Proposal from India for amending the scope of Tyre GTR

Transmitted by the expert from India.

Comments from India on the GTR for Passenger Vehicle Tyres under formulation by the Working Group on Tyres

Fig. 1

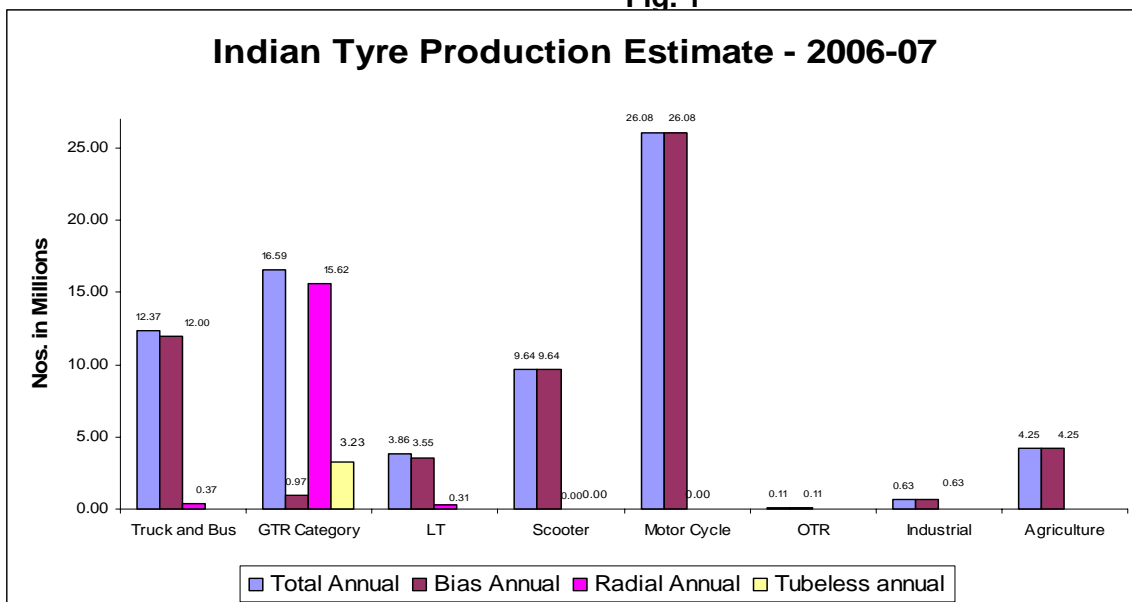
India has large number of Bias tyres still manufactured. The total tyre production (including commercial, passenger, scooter/motor cycle and agricultural vehicles) is estimated to be about 74 million. Out of which, 57 million are Bias ply tyres for the Indian tyre production estimated for the year 2006-07. In passenger segment (which includes LT category also for less than 1250 kg load capacity), the Bias production is about 1.0 million and Radial 15.6 million. The production of Bias tyres is likely to continue for many years (and may even slightly grow in certain applications like non -highway tyres). Bias tyres also constitute a significant part of tyre exports originating from India.

Among the 15.6 million radial tyres produced in the passenger category, only about 3.2 million are in the tubeless category and remaining 12.4 million in tube type. The tubeless production is growing, but complete changeover would take time.

As Bias tyre production and Tube type tyre production is expected to continue in India for more than a decade, these categories need to be addressed in the GTR. This will also help in including some other specific items pertaining to Bias tyres.

Fig. 2

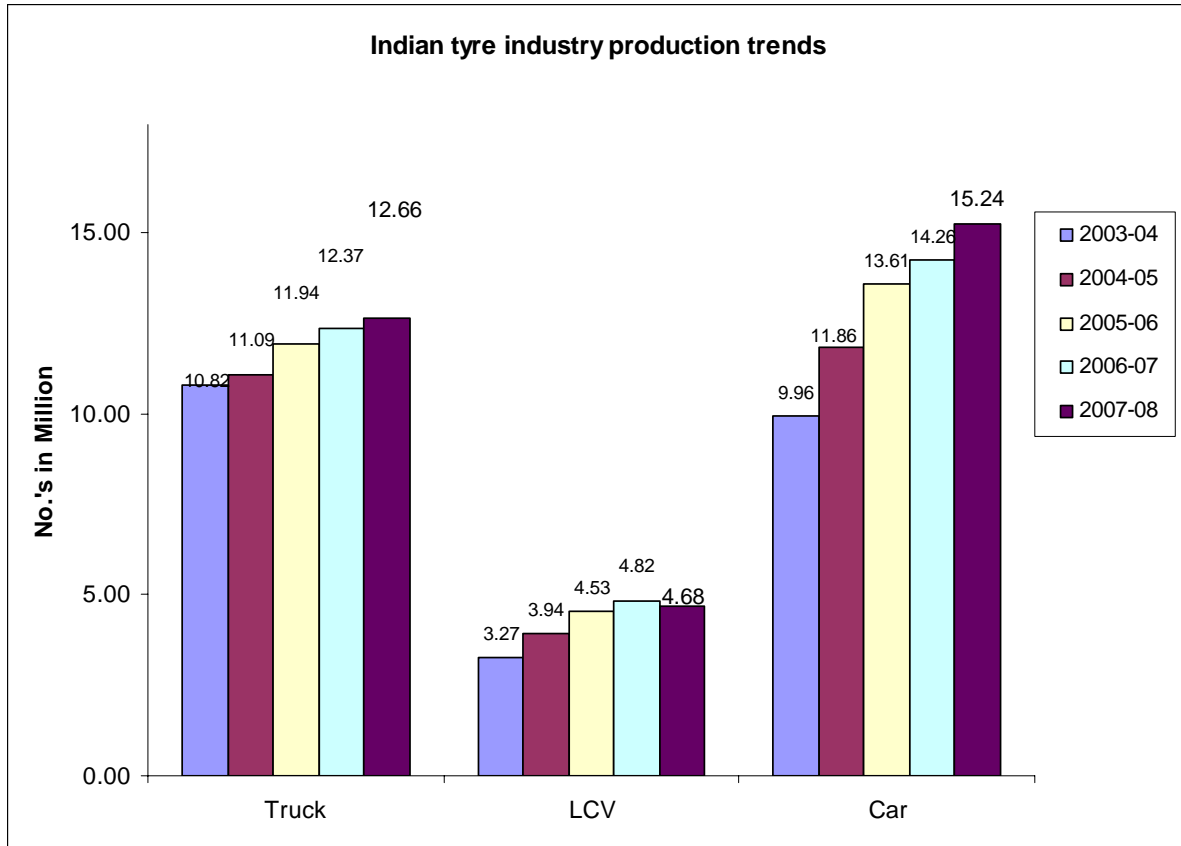
India has a production of about 57 million bias tyres out of the total production of 72 Million tyres. The extent of tubeless tyres produced is only about 15% in the Passenger category. Under such a scenario, and in view of aspects of product 'awareness' and 'Safety' for the end-users, it would be desirable to have "Tubeless" and "Radial" marked on the tyre sidewall. Hence we propose that the current marking of "Radial" & "Tubeless" should continue.

Fig. 3

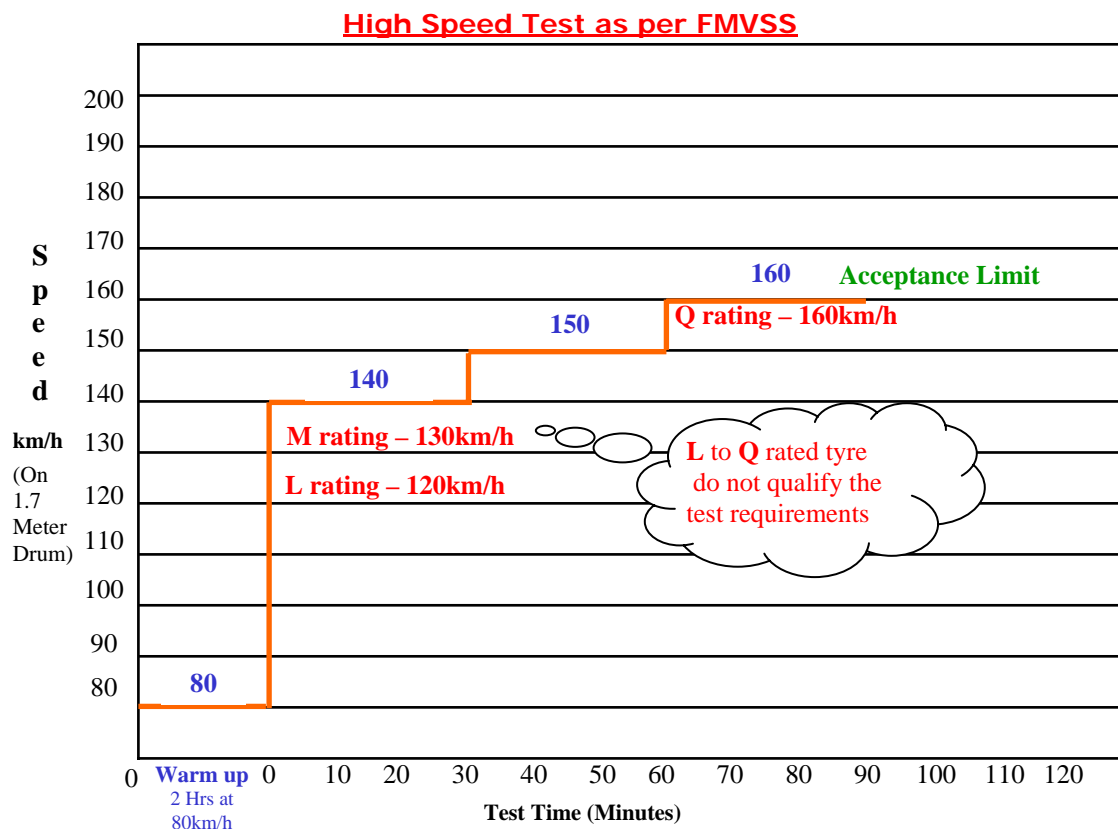
Based on the existing running sizes used in India, there is a group of sizes which have speed ratings from “L” to “Q” (which is 120km/h to 160km/h). This group has max. load capacity of less than 1250 kg, hence does qualify under category of tyres being covered under GTR.

This group, by virtue of its speed rating range, cannot be tested as per FMVSS 139.

The tests applicable to such types of LT tyres needs to be clearly defined and addressed . For example such tyres may not need a high speed test but can have step load test like ECE54.
